Access Compliance Report Public Rights-of-Way (Curb Ramps)

Main Street: CLAWSON_ST		Cross Street: KEMPTON_LN		Location:	SE
ADA ID: RPRK211021153242	Ramp Type: Type 4 - Parallel	Initial Pass/Fail: Fail	Overall Compliance: No	Severity Score:	32
Codes/Mitigation Info/Possible Solution			Field Measurements/Component Compliance

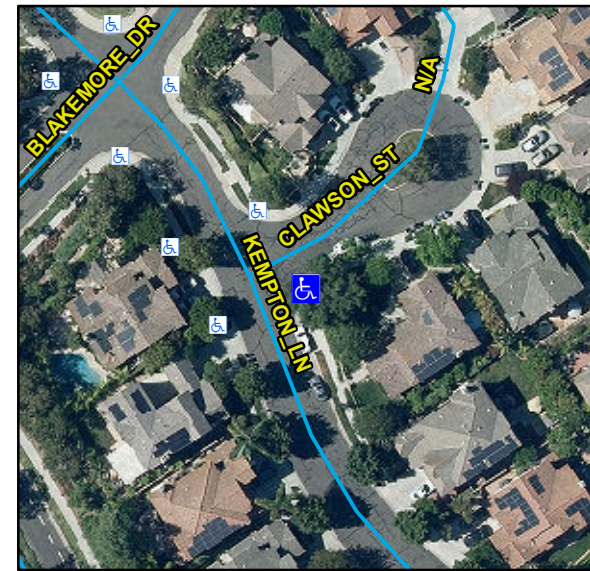
R204.3, R304.3.2, R304.5.3, STD 1115

Compliance	Description	Data	Compliance	Description	Data
N/A	Ramp Length LT (in)	116	N/A	Ramp Length RT (in)	112
Yes	Ramp Width LT (in)	53	Yes	Ramp Width RT (in)	53
No	Ramp Run Slope LT (%)	12.3	Yes	Ramp Run Slope RT (%)	6.1
Yes	Ramp Cross Slope LT (%)	1.3	No	Ramp Cross Slope RT (%)	3.4
N/A	Landing Present	N/A	N/A	DWS Provided	N/A
N/A	Landing Length (in)	N/A	N/A	DWS Contrast	N/A
N/A	Landing Width (in)	N/A	N/A	DWS Length (in)	N/A
N/A	Landing Run Slope (%)	N/A	N/A	DWS Full Width	N/A
N/A	Landing Cross Slope (%)	N/A		DWS Offset Type	N/A
N/A	Landing Movement Obstructed?	N/A	N/A	DWS Offset Left (in)	N/A
	Landing Movement Type	N/A	N/A	DWS Offset Right (in)	N/A
N/A	Landing Shared	N/A			
N/A	Clear Space	Yes			
N/A	Clear Space To Crosswalk (in)	N/A			
N/A	Marked Crosswalk 1	No	N/A	Marked Crosswalk 2	No
	Crossing 1 Direction	N		Crossing 2 Direction	W
	Marked Crosswalk 1 Width (in)	N/A		Marked Crosswalk 2 Width (in)	N/A

Remove & Replace Curb Ramp With Two New Directional Ramps or Equivalent.
